## **ADDENDUM #1**

March 11, 2025

### **RE: MILAN HOUSING RENOVATION**

The following items are clarifications, additions or modifications to the Bid Documents.

1 Overall Floor Plan  
Scale: 1/8" = 1'-0"

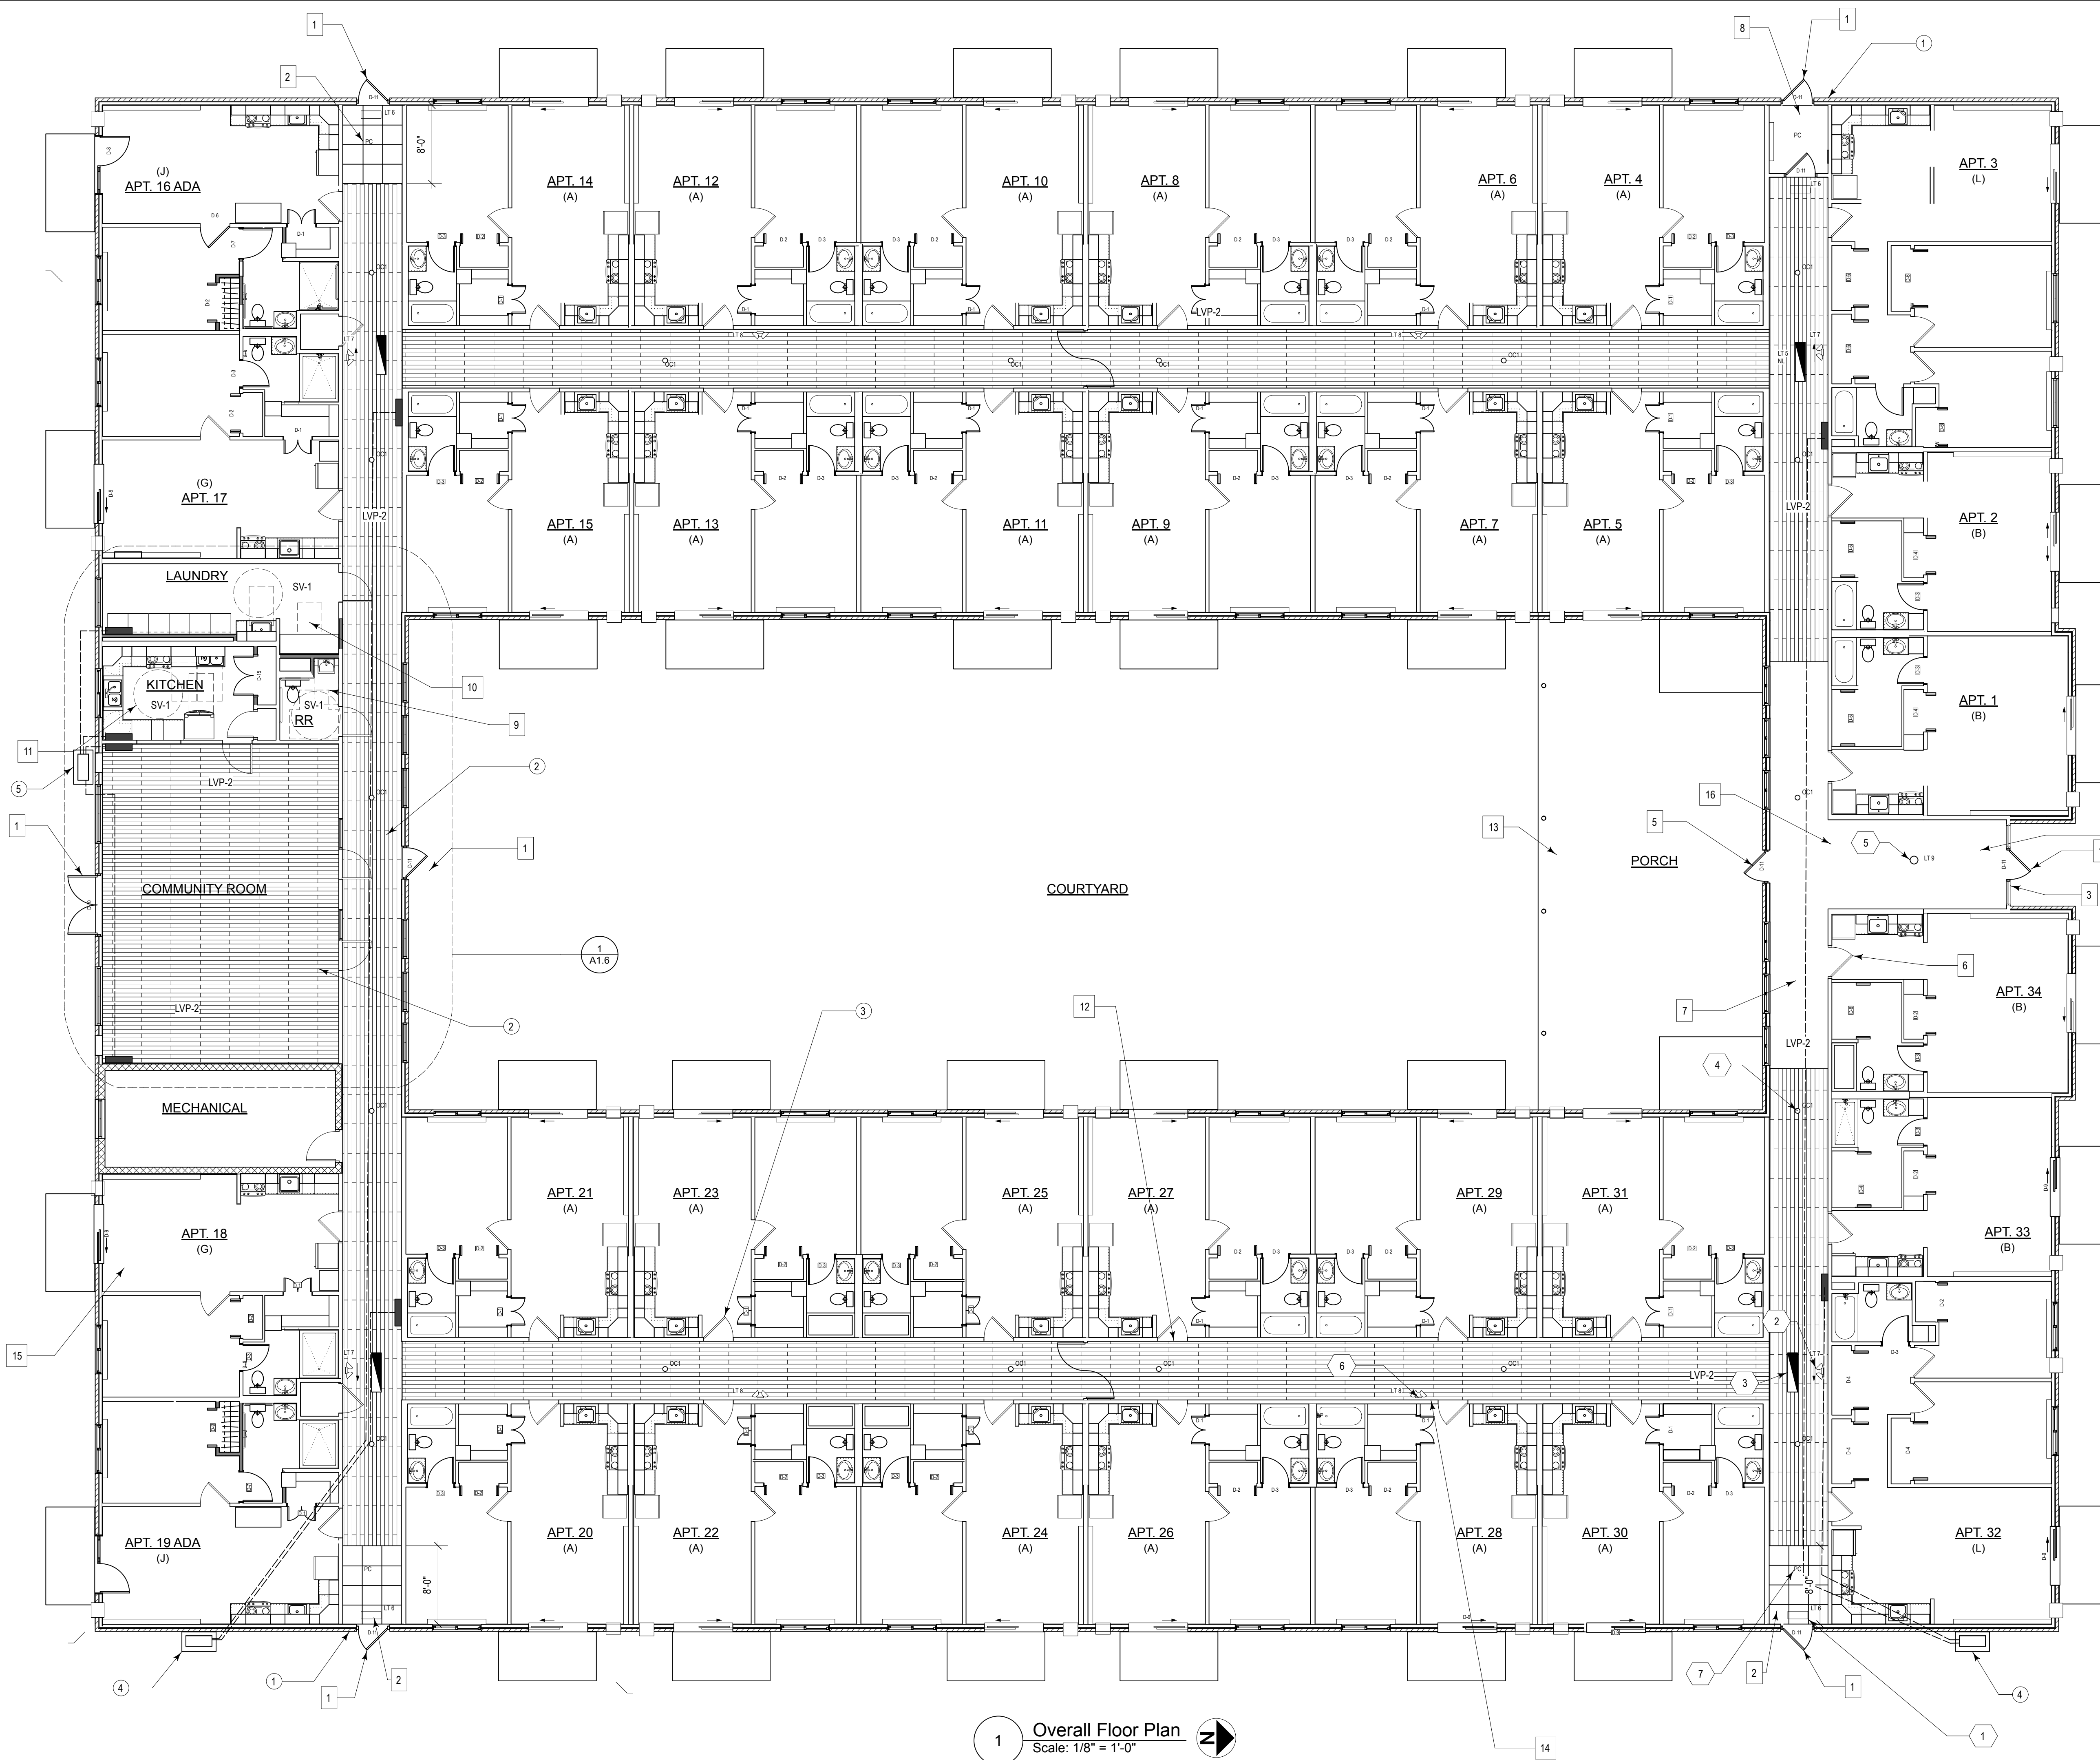
- A. Yes
7. Q: It appears like there are currently shut-valves installed to control groups of 4 or so apartments, and, the piping to each apartment appears to be installed in such a way that installing the required shut-off valves for each unit will be very difficult to price without doing selective demolition. What should we do.

NO.	DATE	ISSUE NOTE
A	3/11/25	Remove scope in #12
REV.	DATE	DESCRIPTION

- A. We will eliminate the new shut-off valves called out in the drawings. See revised sheet A1.0.
8. Room finishes schedule & legend have been revised. See new A3.0 sheet.
